Service Bulletin

SB-10057653-4981

SUBJECT: Service Update for Inventory and Customer Vehicles
Accessory Drive Idler Pulley Failure
Expires with Base Warranty

MODELS: 2015 Chevrolet Camaro
Equipped with V8 Engine (L99/LS3/LSA/LS7)
2015 Chevrolet Silverado
2015 GMC Sierra
Equipped with V6 Engine (LV3)

4063612

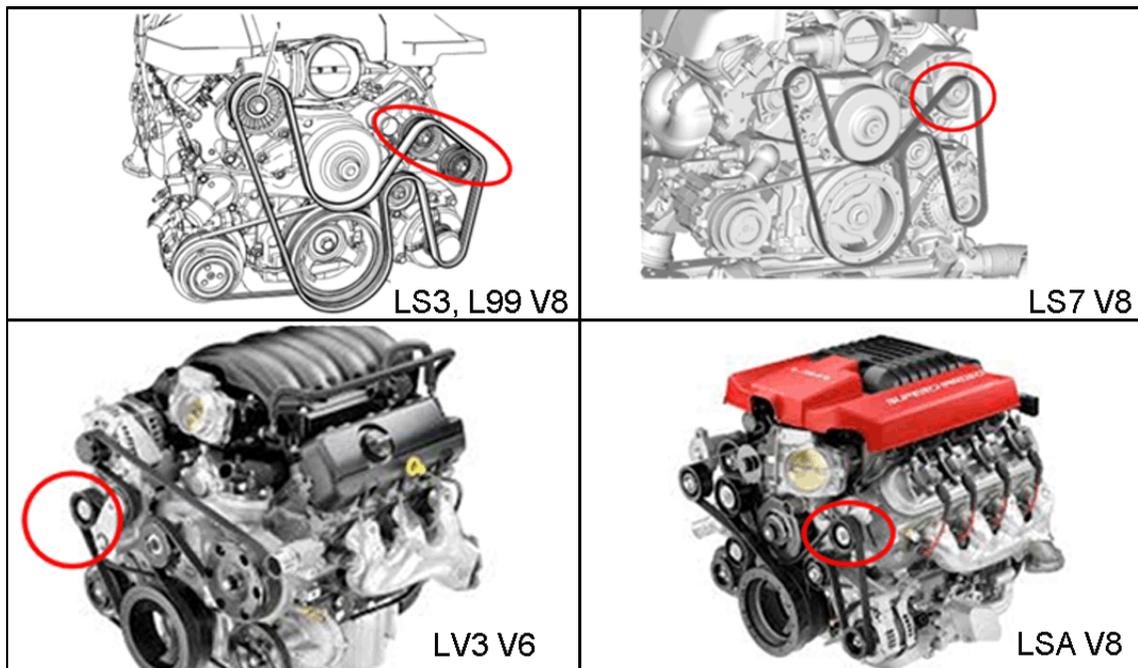
Note: Remove and replace both drive belt idler pulleys on engines with RPOs LS3 and L99. Refer to the photograph above to determine the location of the drive belt idler pulley(s).

1. Remove the drive belt idler pulley. Refer to *Drive Belt Idler Pulley Replacement* in SI.
2. Install a new drive belt idler pulley. Refer to *Drive Belt Idler Pulley Replacement* in SI.
